INDEPENDENT HYDROGEOLOGICAL ASSESSMENT

PROJECT NO. 21220054

INDEPENDENT HYDROGEOLOGICAL ASSESSMENT

Report researched and produced by B. A. Hydro Solutions Limited (BAHS Ltd) on the instruction of the Wardens Trust.

Figure 9: Modelled particle traces

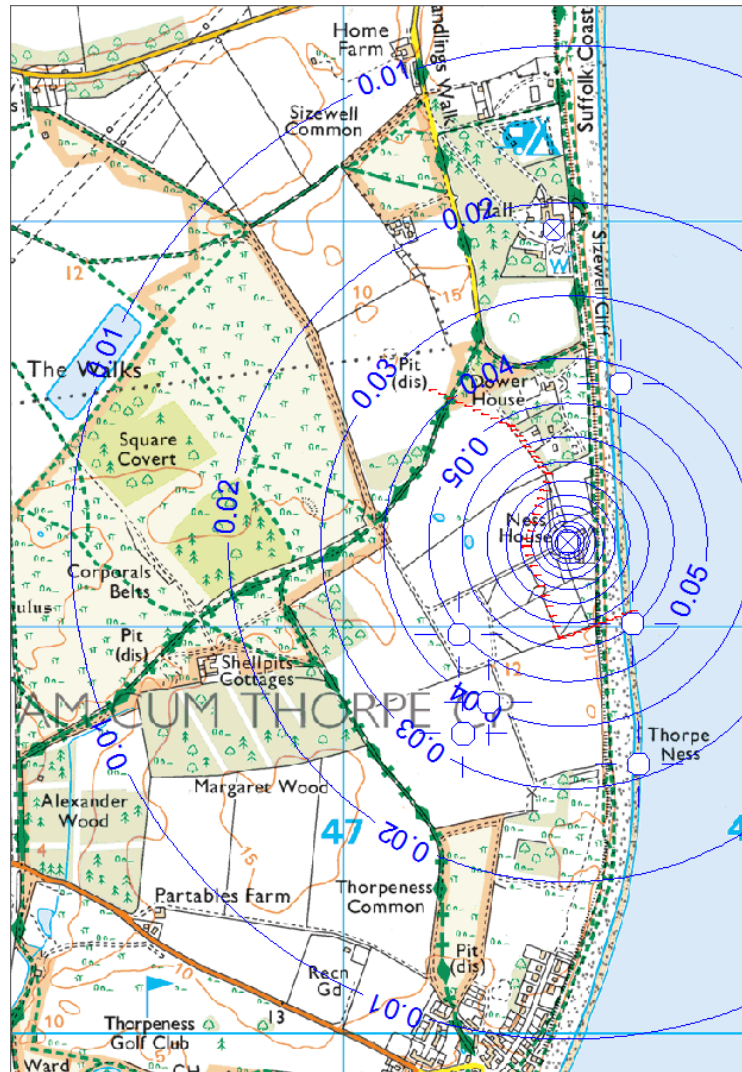
This output shows the Well would be vulnerable to disturbance to the ground along the line of the cables where it passes nearby and any contamination that may enter the ground. The model suggests there would be limited movement of groundwater from the directional drill location to the Well while there is free movement of groundwater in the aquifer. This model cannot, unfortunately, simulate what might happen if the directional drill was to result in an east-west barrier to groundwater flow. As the radius of drawdown is shown to extend to beyond the directional drill area, any change in the ground's ability to store and

transmit groundwater in that area will distort natural and abstraction induced groundwater flow directions. That would then result in a change in the source/recharge area that sustains the Ness House abstraction.

Figure 10: Modelled circular particle traces after 3+ years

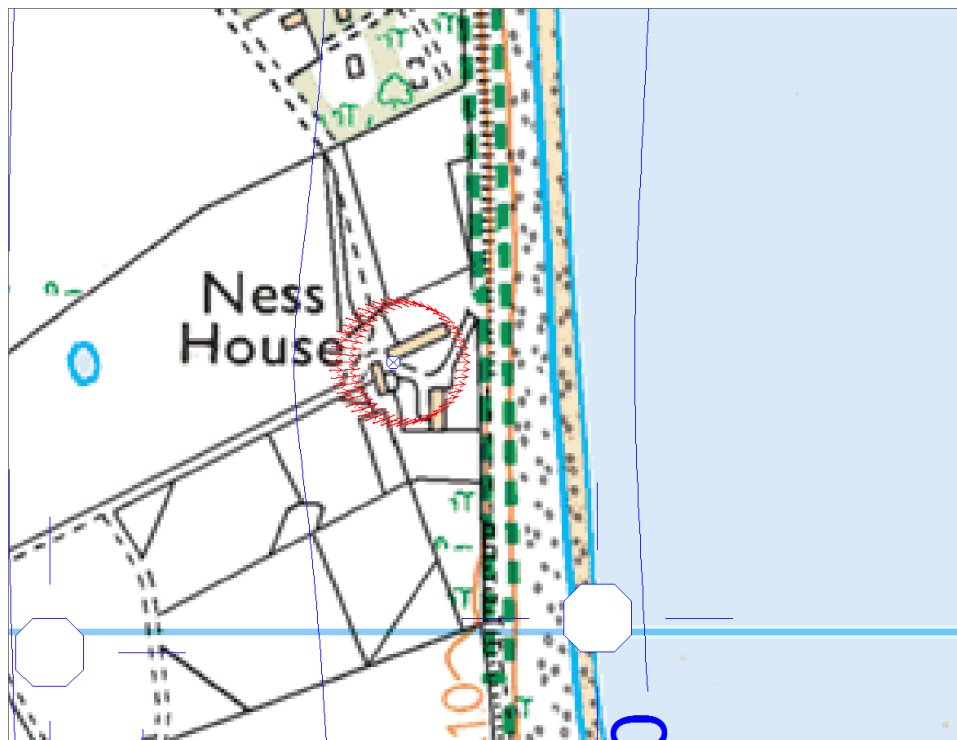
If the recharge/source area is at all changed, as a result of the permeability/transmissivity reducing due to grout loss from directional drilling, then the source/recharge area will change. That could result in a reverse in groundwater flow between the Well and the shore if there is less water available from elsewhere in the aquifer to sustain the abstraction. Modelling thus shows the well and groundwater quality could be vulnerable to shallow ground works near the boundary and the amount of groundwater as a result of works to the south of the Well, leading to an imbalance in the saline/fresh water interface and problems with water quality.
